ALAMOS GOLD INC.

**Lynn Lake Gold Project
Environmental Impact Statement**

**Federal IR Responses
Round 1, Package 2**

June 1, 2021

Horizontal Hydraulic Conductivity with Depth

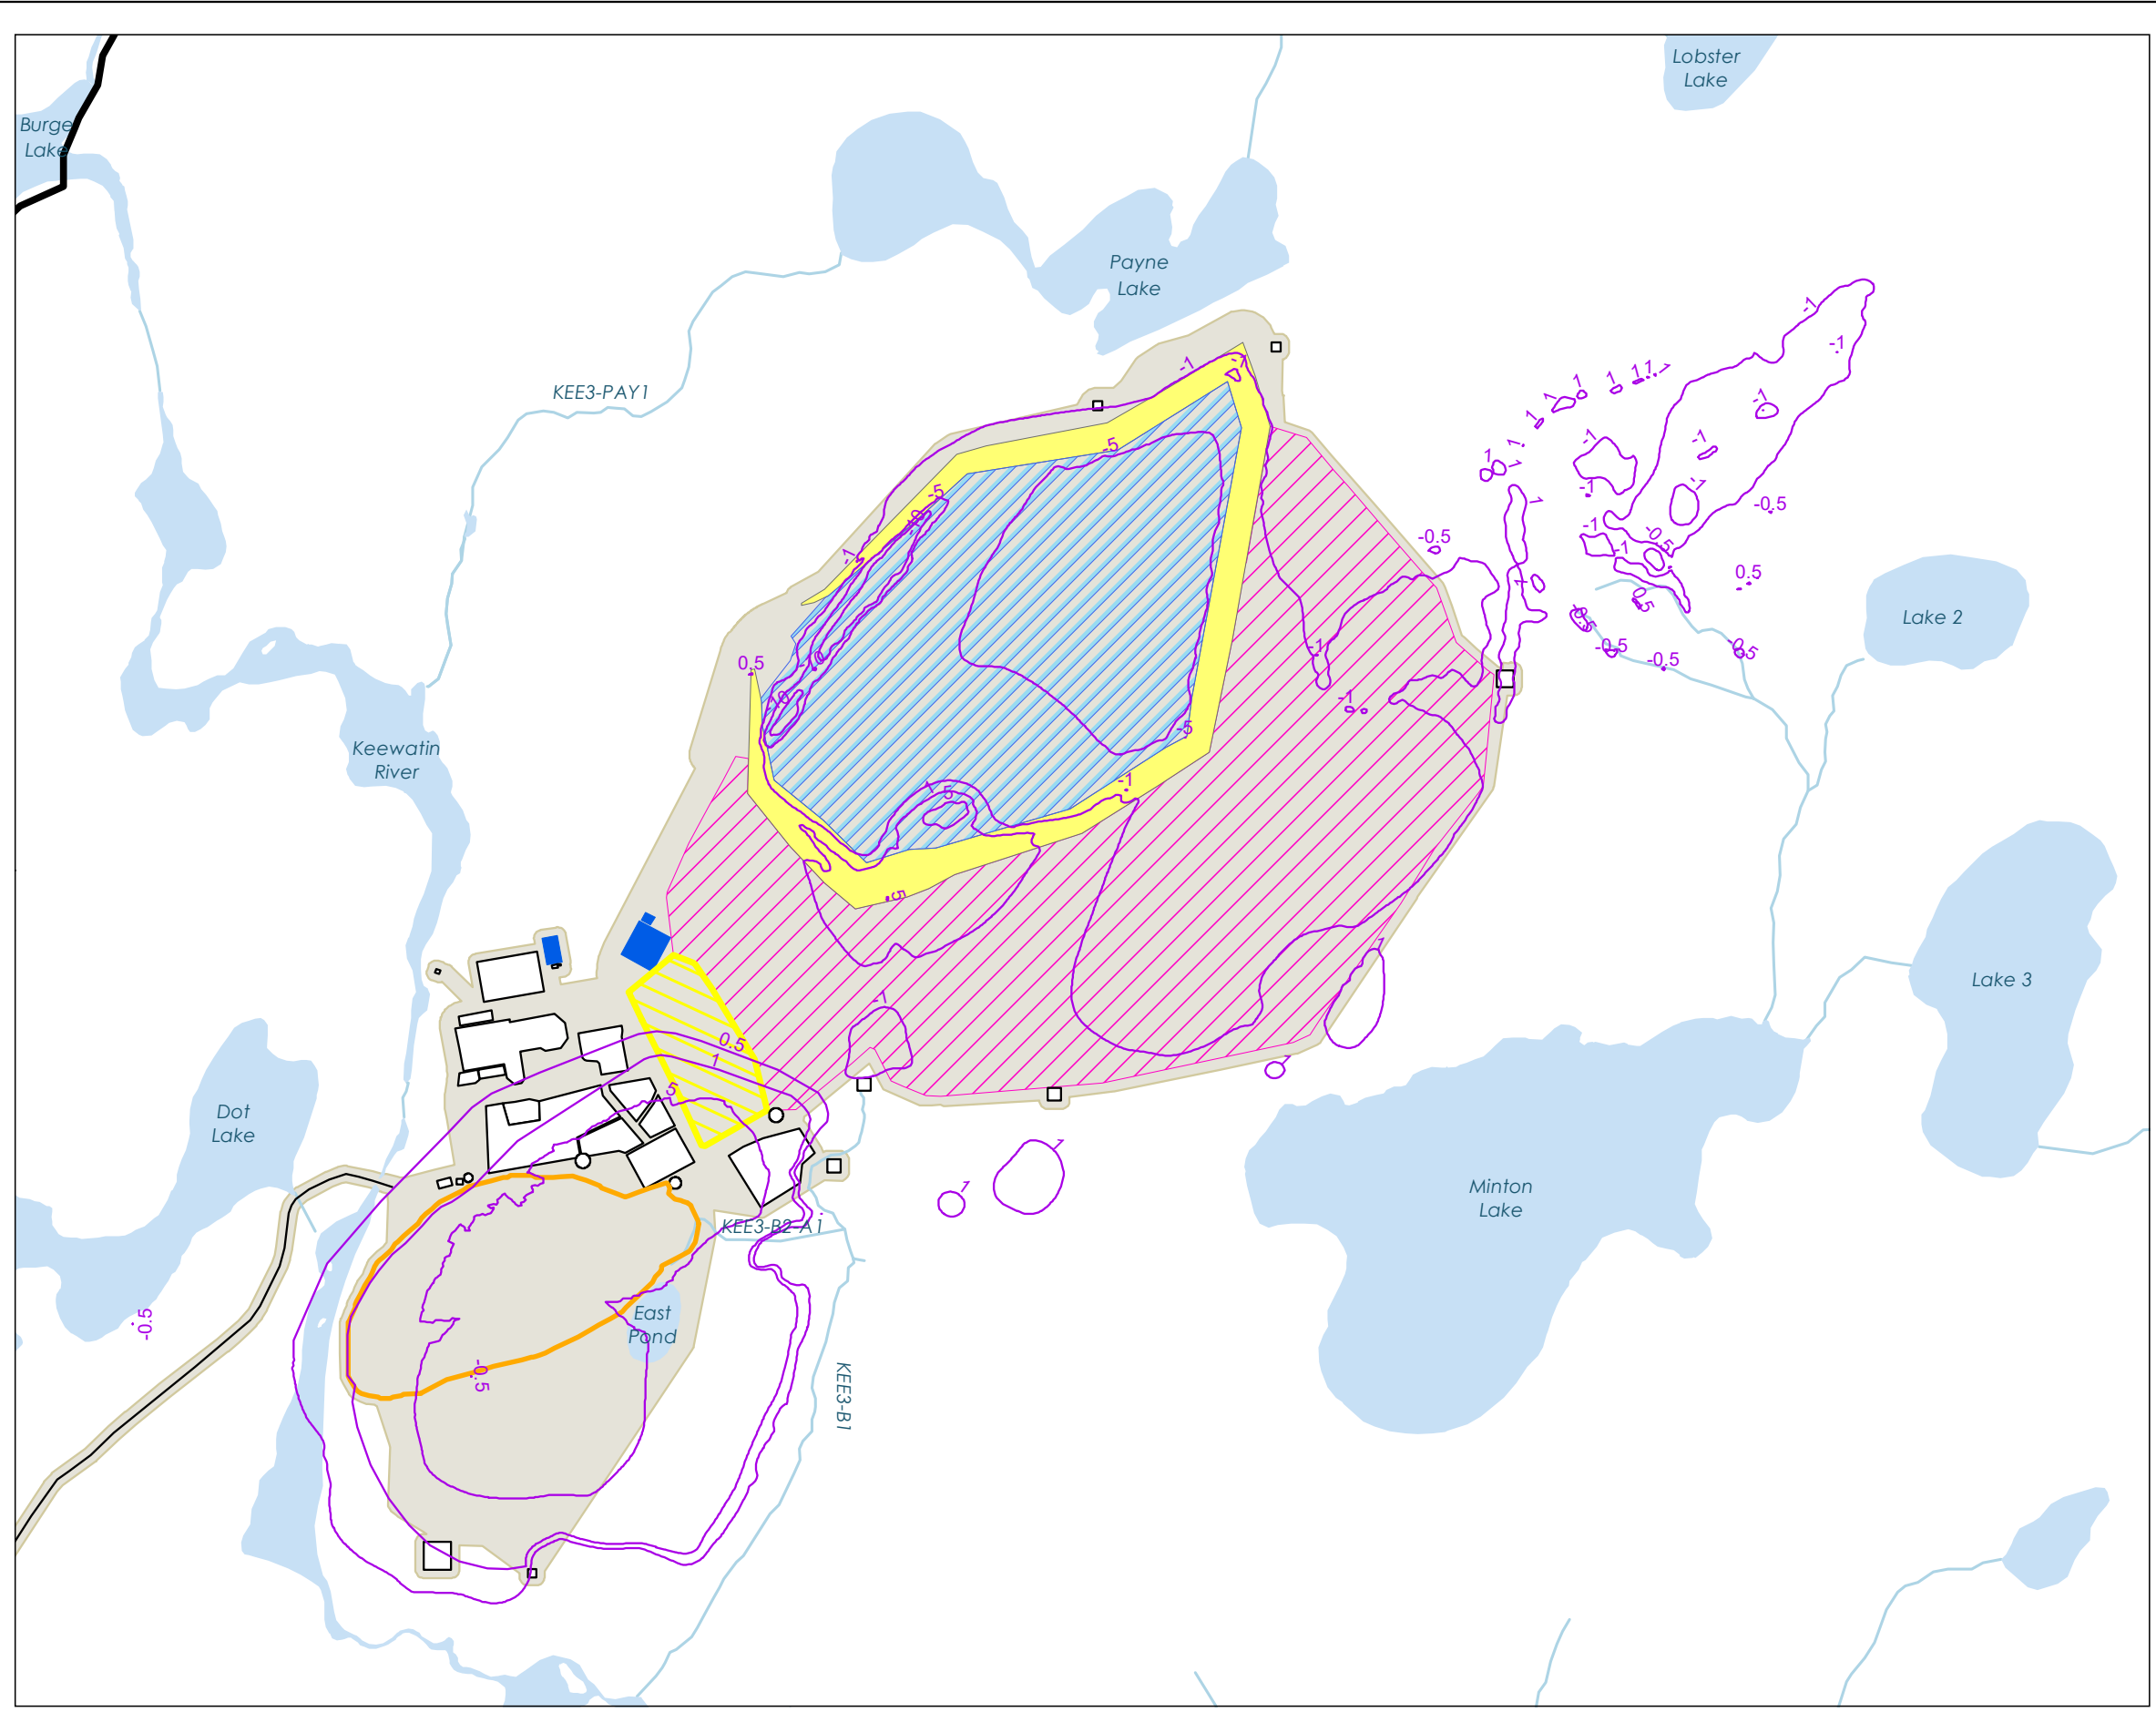
ID:	IAAC-62
Expert Department or Group:	NRCan-07
Guideline Reference	6.1.5 Groundwater and Surface Water
EIS Reference	8.2.2.3 Estimation of Hydraulic Conductivity Figure 8-1 Volume 4, Appendix H 4.2.1.3 Hydraulic Conductivity 4.2.2.3 Hydraulic Conductivity, Volume 5, Appendix F Lynn Lake Gold Project, Hydrogeology Assessment – Gordon site Technical Modelling Report, 3.3.5 Bedrock, Appendix G Lynn Lake Gold Project, Hydrogeology Assessment – MacLellan site Technical Modelling Report, 3.3.5 Bedrock
Information Request:	<ul style="list-style-type: none"> a. In figures showing the relationship between depth below the top of bedrock and hydraulic conductivity, indicate which tests are completed in which bedrock zone (shallow, upper, intermediate, or deep). b. Provide the rationale for the depth selection for each bedrock subdivision. c. Describe the lack of testing of the deep bedrock zone at the Gordon site and the potential impact on model results. d. Describe the results of testing at the MacLellan site in the intermediate and deep bedrock, and the evidence for a reduction in hydraulic conductivity with depth. e. Describe any gaps in information and related uncertainty with regards to the assessment of effects to groundwater. Describe any additional mitigation measures and/or monitoring and follow-up, including adaptive management that would be implemented.

Response:	<ul style="list-style-type: none"> a. Figure 8-1 in Chapter 8 of the Environmental Impact Statement (EIS) (Volume 1) presents the hydraulic conductivity with depth below top of bedrock. The graph presents the length of the bedrock interval tested as well as the type of hydraulic test completed, whether it was a packer test, pumping test, or slug test. Within the groundwater flow models for the Gordon and MacLellan sites, the bedrock was divided into shallow, upper, intermediate, and deep bedrock. Figure 8-1 was updated to reflect the division of bedrock in the model layers compared to hydraulic conductivity with depth, and is presented as attachment, Figure IAAC-62-1, to this response, with the following description: At the Gordon site, shallow bedrock was defined as the upper 50 m of bedrock. Three packer tests and 55 slug tests were completed within the shallow bedrock. Based on the results of the packer testing, which indicated relatively higher hydraulic conductivity of bedrock compared to the MacLellan site, and historical interactions of the historical open pits and Gordon and Farley lakes, two pumping tests were also completed at the Gordon site to estimate hydraulic conductivity of bedrock. The upper bedrock was defined as the 50 to 100 m depth of bedrock. Three packer tests and one pumping test were completed within the upper bedrock. The intermediate bedrock was defined as the 100 to 150 m depth of bedrock. Two packer tests were completed within the intermediate bedrock. The deep bedrock was defined as greater than 150 m depth below bedrock with a unit thickness of 33 m. There was no hydraulic testing data available for the deep bedrock.

**Figure IAAC-114-1 Wind Rose and Wind Frequency Distribution Diagram at Lynn Lake Airport, Manitoba (2015-2018)
(Updated Figure 6A-1 from Chapter 6 of the EIS)**

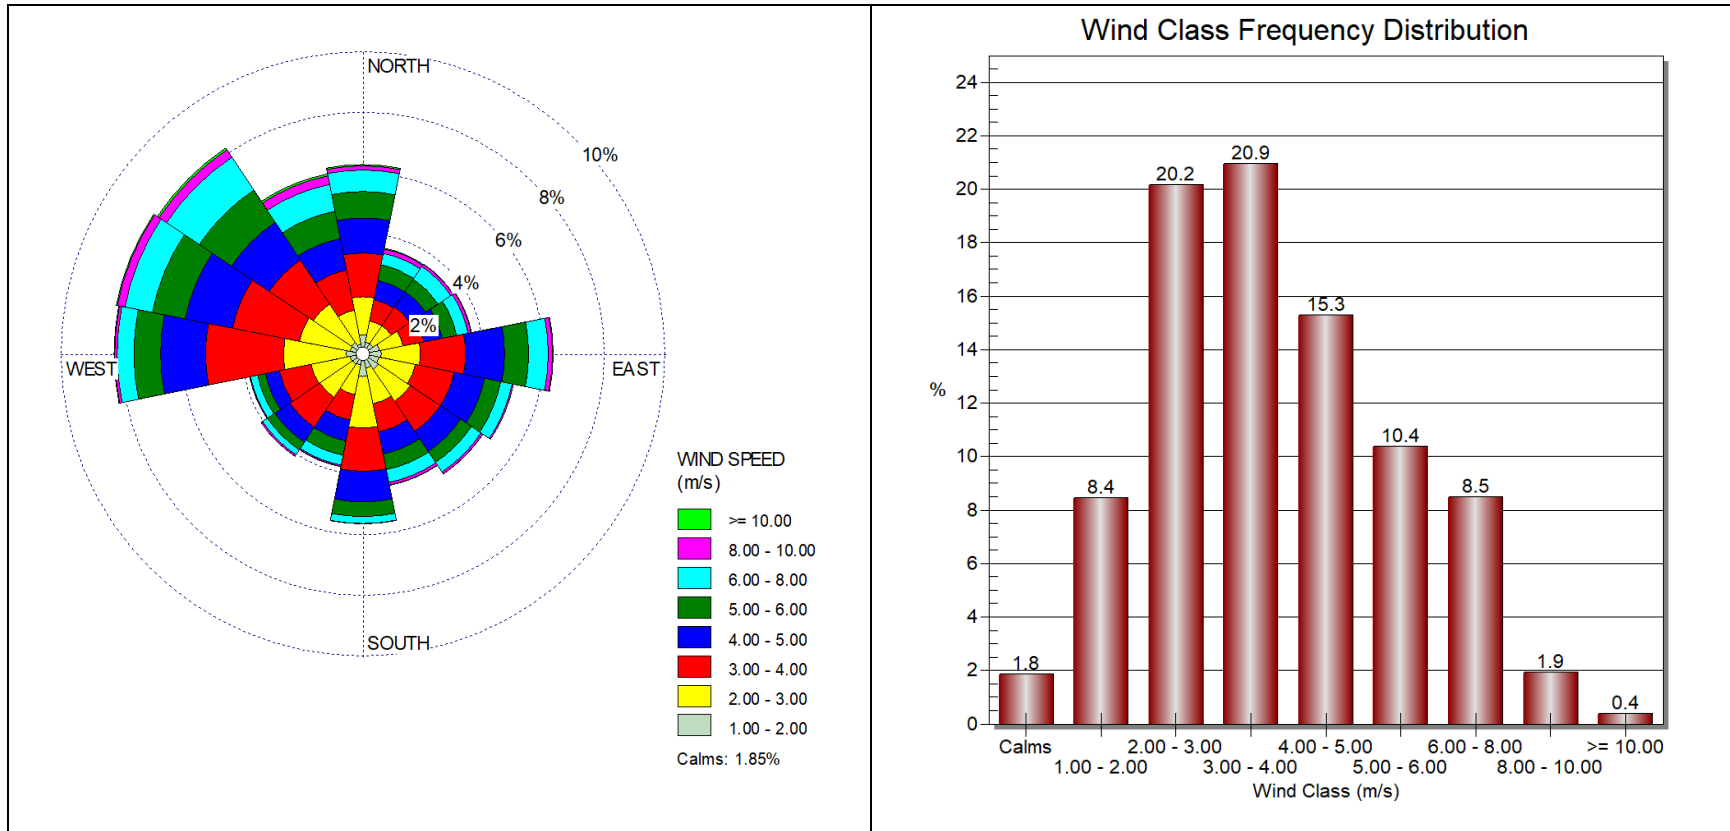
ID:	IAAC-114
Expert Department or Group:	ECCC-02 MCCN-89
Guideline Reference	6.1.1 Atmospheric Environment 6.5. Significance of residual effects
EIS Reference	6.2.2.1 Climate and Meteorology Figure 6A-1 18.7.1 Significance of Project Residual Effects
Information Request:	<p>a. Verify and describe the accuracy of Figure 6A-1 (and associated text in Section 6.2.2.1) reporting that 0% of wind data is considered to be calm (<1 m/s). If it is verified the identified wind data is accurate, clarify how it was determined that 0% of wind data is considered calm.</p> <p>b. Indicate whether the correct wind data was appropriately captured in the atmospheric dispersion models used to determine changes to air quality.</p> <p>i. If incorrect data was used, update the atmospheric dispersion models with the appropriate wind data and subsequently, update the effects assessment for atmospheric environment. Describe any changes to the exceedances of criteria air contaminants (CACs) and contaminants of potential concern (COPCs) noted in the EIS and the timeframes for the anticipated exceedances.</p>

ID:	IAAC-114
	<p>in Volume 5, Appendix A, Attachment D, Figure D 2. Figure D-2 shows that there is a general agreement between the measured and predicted wind roses, both indicating predominant winds from northwest, west, north and east, and with most frequent wind speeds between 2 m/s and 4 m/s. The five-year meteorological data created with WRF® and CALMET® is therefore viewed as being representative of the wide range of weather conditions that could occur in the region.</p> <p>i. The five-year meteorological data (2012-2016) created with the WRF® and CALMET® meteorological models is representative of the wide range of weather conditions that could occur in the region and is appropriate for use in the dispersion modelling of Project emissions. Therefore, no update to the atmospheric dispersion model is required.</p> <p>References:</p> <p>Scire J.S., F.R. Robe, M.E. Ferneau and R.J. Yamartino. 2000a. A User's Guide for the CALMET Meteorological Model (Version 5). Earth Tech Inc. January 2000. Available at: http://www.src.com/calpuff/download/CALMET_UsersGuide.pdf. Last accessed on January 20, 2021.</p> <p>Scire, J.S., D.G. Strimaitis and R.J. Yamartino. 2000b. A User's Guide for the CALPUFF Dispersion Model (Version 5). Earth Tech Inc. January 2000. Available at: http://www.src.com/calpuff/download/CALPUFF_UsersGuide.pdf. Last accessed on January 20, 2021.</p> <p>Scire, J.S., D.G. Strimaitis and R.J. Yamartino. 2011. CALPUFF Modelling System Version 6. User Instructions. Earth Tech Inc. April 2011. Available at: http://www.src.com/calpuff/download/CALPUFF_Version6_UserInstructions.pdf. Last accessed on January 20, 2021.</p>
